Courtyard enclosure study · closing the conditioned house around the open courtyard · Taif / Palm House V7.1

Design review Y-01 (critical) · 30 Oct 2026 · the windows follow `docs/DESIGN_LANGUAGE.md` (black steel, divided lites)

DECIDED: option A (owner, 30 Oct 2026, applied in V7.0): the projection 1.55 m, B3 / R11 / C21–C23 at x 5.80, W1 / W2 / W3 as in § 2. The "now" column below is the V6.3 state (edge x 5.60), kept as the record of the comparison.

Plans of the gallery strip, first floor · now / A / B · the sky opening and the void · about 1:115 on A4

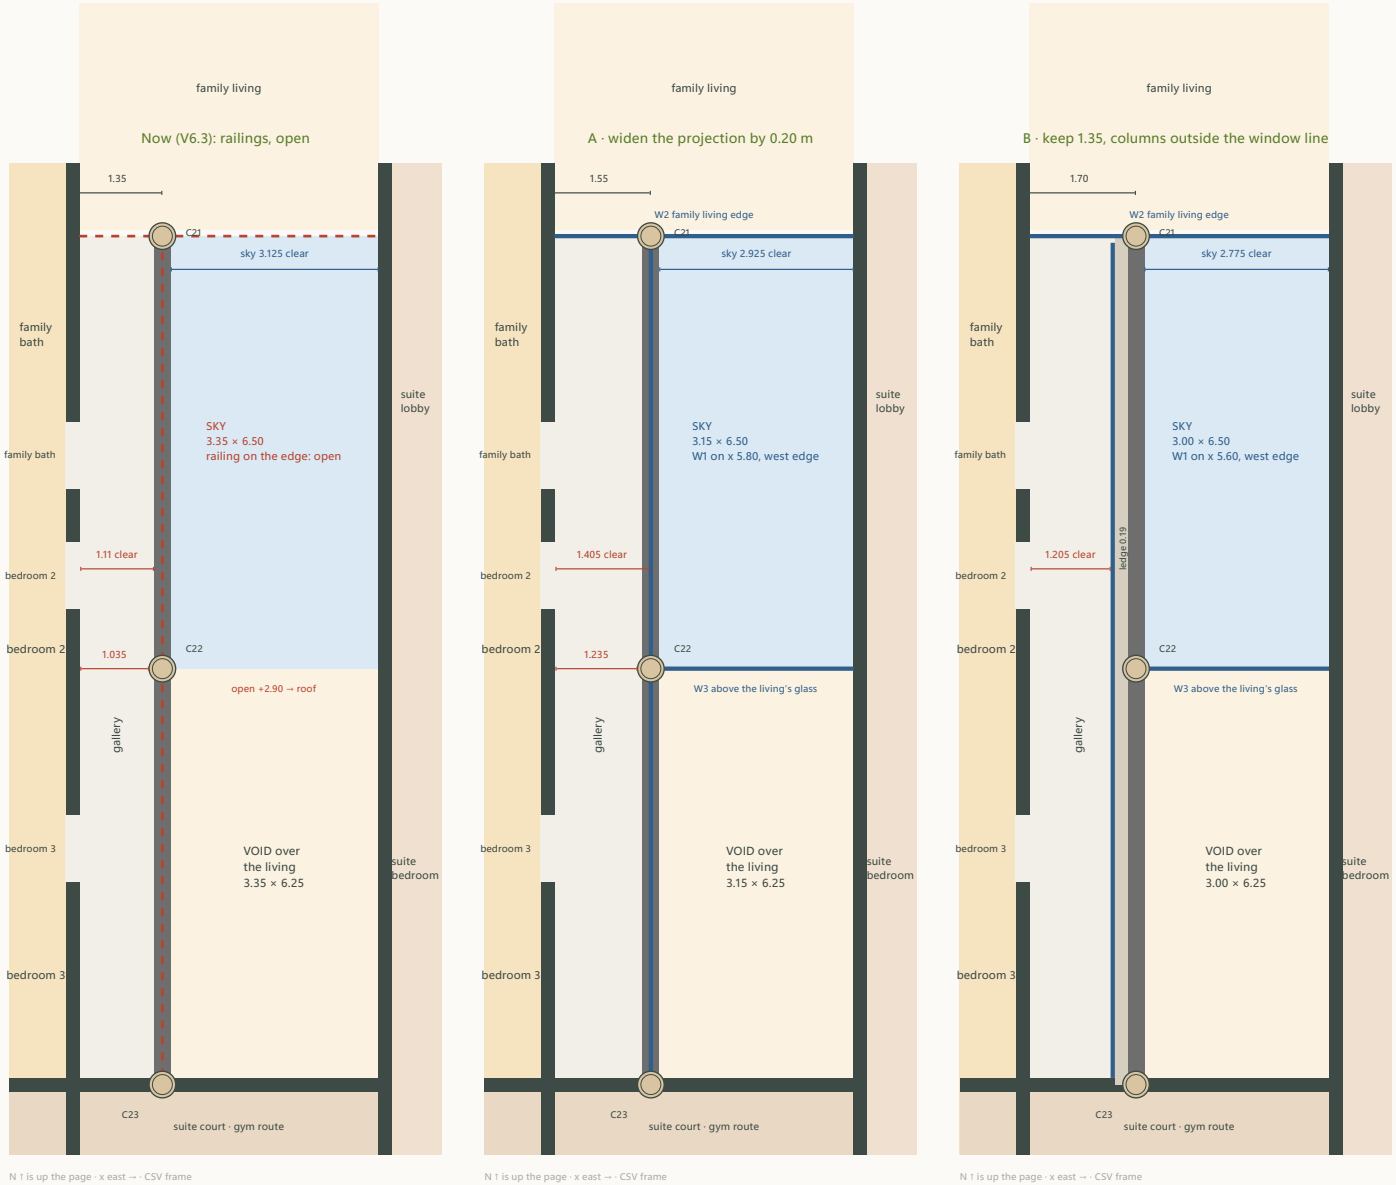
Today the gallery is 1.11 m clear between the rooms' finished wall face (x 4.365) and the upstand of B3, and 1.035 m at the three stone column sleeves (Ø0.4). A window on the line changes little by itself; the columns are the problem. Two ways to reach 1.20 m:

4 · Recommendation: A **A** keeps everything on one line: the beam, the columns, the window and the railing base are the same element, the gallery is 1.405 m clear and 1.235 m at the columns, the sky loses 6 % of its area and stays 3.15 m wide on axes. **B** reaches 1.20 m with no margin (1.205 m), narrows the sky more (3 m: the beam and the roof edge must follow the columns), and adds a 0.35 m ledge outside the glass that must be waterproofed, capped and kept clean; its one real gain, free-standing columns in front of a glass wall, is a stronger colonnade image. If the owner wants that image, B is buildable; otherwise A. In both, the two-storey columns, the upturned B3 and R11 stay as decided (X8); only their x changes. **Study checks passed** (7)

Sections through the courtyard (y ≈ 10, looking north) · A and B · about 1:105 on A4

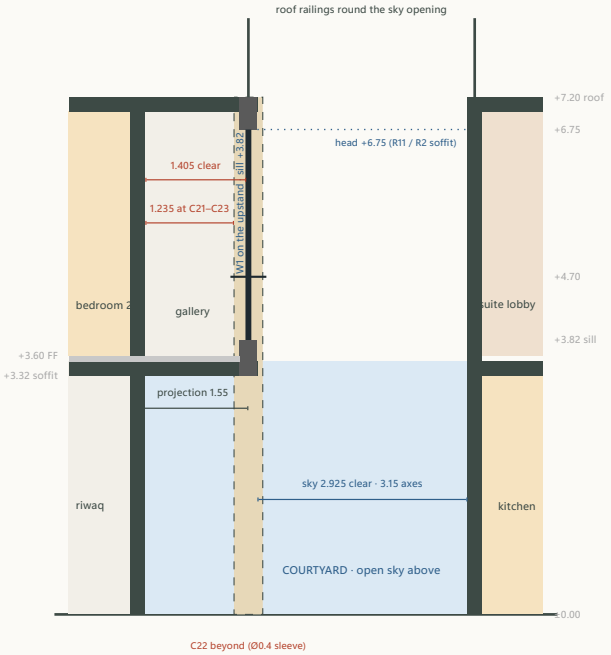
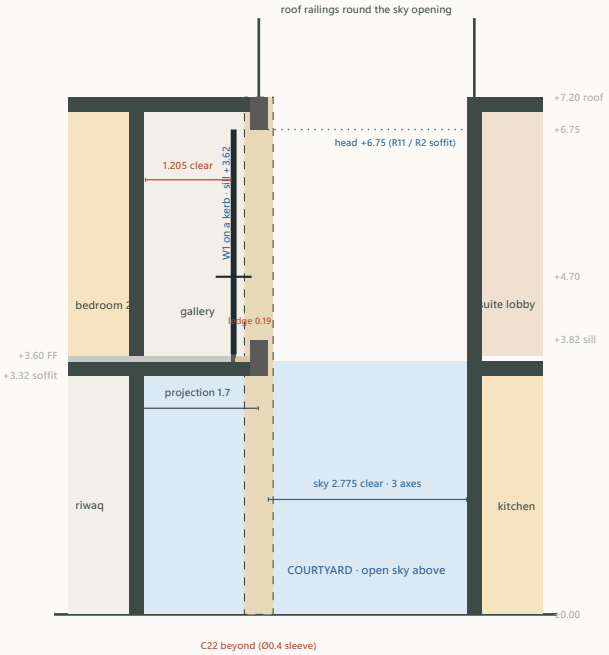
Both options. W1 bears on the upstand of B3 (the window's dead load is small; the upstand becomes its sill and its anchor, 0.25 wide); W2 on B2 (floor-level sill, the frame anchored to the slab edge and R1); W3 spans +2.90 → +6.75 between C22 and the kitchen wall, held top and bottom (R2 above; a steel transom at +3.82 tied to C22 and the wall takes the wind of the 3.85 m height; the courtyard well has little wind). The head line is the soffit of R1 / R2 / R11 at +6.75 over the void (y 13–19.25) a 0.25 m fascia keeps the same line under the roof slab. Nothing new for the engineer except the window anchors and, in B, the ledge.

- **A:** B3, R11 and C21–C23 move 0.20 m east to x 5.8 the projection slab bay becomes 1.55 m (slabs-ff row "the projection"), the roof strip over the gallery 1.55 m (slabs-roof); C22 stays the pier in the living's courtyard glass (now at x 5.8), C21 in the women's majlis glass, C23 in the living's south wall; the spans (6.5 / 6.25) are unchanged, R2's west end lands on C22 at x 5.8. The sky opening is 3.15 × 6.5 m.

- **B:** B3, R11 and C21–C23 move 0.35 m east to x 5.95 the slab bay becomes 1.7 m with the window line 0.35 m inboard of the beam on a 0.10 m kerb; the ledge between the kerb and the upstand is waterproofed and capped (stone, falling out). The columns stand free in the courtyard and in the void: C22 is a free column in the living's courtyard glass line, 0.35 m in front of the upper window W3 (W3 then runs behind it, from the W1 line at x 5.6 to the kitchen wall, 3.25 m). Alternative B2 (not recommended): B3 stays at x 5.6 and reaches the columns at x 5.95 on short corbels; two lines of concrete for one edge.

W1 · the gallery line seen from the courtyard and the void (looking west) · option A · 1:70 on A4

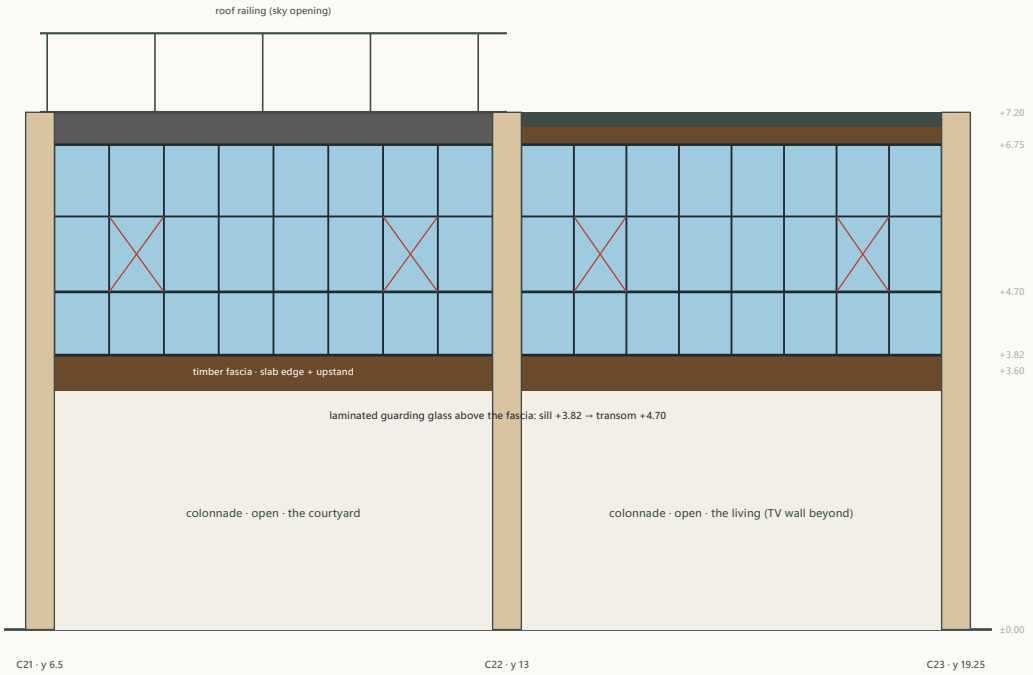
The air / thermal line runs **on the structure that is already there**: along the gallery on the upstand of B3 (the glass sits on the upstand top at +3.82, 0.22 above the gallery floor: the splash and dust line of a courtyard), along the family living's edge on B2 from the floor, and on y 13 over the living's glass up to the roof edge beam R2. All three heads meet the one soffit line of the roof edge beams R1 / R2 / R11 at **+6.75**, so the courtyard reads as one room with one cornice.

Window	Line	Sill	Head	Lites and operation
W1 gallery edge	x 5.8 (A) / 5.6 (B), y 6.5–19.25	+3.82 (upstand)	+6.75	guarding transom at +4.70 (1.10 above the floor), laminated glass below it; above it lites ≈ 0.75 wide; one inward side-hung casement per bay (two bays, four casements) for calm nights and cleaning
W2 family living edge	y 6.5, x 4.25–8.95	+3.60 (floor)	+6.75	same transom at +4.70, laminated below; two inward casements; no door (the courtyard is reached from the ground floor)
W3 living, upper courtyard side	y 13, C22 → x 8.95	+2.90 (the glass head) or ±0.00 if the ground-floor glass is remade as one steel wall	+6.75	transoms at +2.90 and +3.82 (the gallery's sill line), lites ≈ 0.75 wide; two motorised bottom-hung tilt lites at +3.82–+5.40 for the night mode

Cleaning from inside. W1: both faces from the gallery: the inside directly, the outside through the open casements (every lite within an arm's reach of a casement, the glass height 2.93 m). W2: as W1 from the family living. W3: the inside from the living floor with a water-fed pole (top +6.75); the outside from the courtyard floor with the same pole (6.75 m) or from the gallery's casement at its west end. The courtyard floor's hose point (Y-04) serves the pole. **Frames.** Black steel, thermally broken, divided lites, double low-e glass, dust seals, insect screens on the casements. Depth ≈ 0.06 m on the line; the stone column sleeves stop at the frame with a sealed joint (A) or stand free (B).

V7.1 (owner, 31 Oct 2026): semicircular heads and the courtyard arcade. Every enclosure window gets a semicircular (Roman) arched head in black steel with divided lites, the arched head fixed, the rectangular part below with the operable lites; the sill and the guarding transom (+4.70) as in § 2. **W1:** six arched windows 1.60 m wide on the gallery edge, three per column bay, sill +3.82, springing +5.80, crown +6.60, 0.15 m of wall below the R11 / R2 soffit (+6.75): in the courtyard bay they stand over the three bays of the new arcade (y 6.783–8.383, 8.950–10.550, 11.117–12.717), in the void bay on three equal bays (13.242–14.842, 15.325–16.925, 17.408–19.008); the four casements sit in the lower parts. **W2:** two arched windows 1.30 m wide east of C21 (x 6.00–7.30 and 7.55–8.85), floor to the crown +6.60, springing +5.95; the strip x 4.25–5.80 of that edge is the family living's opening to the gallery's north end, no window. **W3:** one arched window 2.80 m wide (the whole space between C22's stone sleeve and the east wall; the brief said ≈ 3.0) over the living's courtyard glass, +3.32 to the crown +6.60, springing +5.20, the two motorised tilt lites in its lower part; 0.15 m of wall to the R2 soffit. **The arcade:** in the courtyard bay only, two slender honey-stone columns Ø0.25 on x 5.80 at y 8.667 and 10.833 (three equal bays of 2.167 m on axes) with three semicircular arch plates under the projection's soffit (+3.27): spans 1.84 / 1.92 / 1.84 m between the sleeves, springing +2.35 / +2.31 / +2.35, crown +3.27; decorative unless the engineer uses the columns (`studies/structure.typ` X18); the living bay keeps no arches. The columns stand 0.78 m clear of the sunken seating's west edge, 1.36 m clear of the riwaq door's swing line, 1.33 m from the riwaq glass face; the malqaf outlet is on the east wall. The courtyard reads as a two-tier arcade: three arches below, three arched windows above.
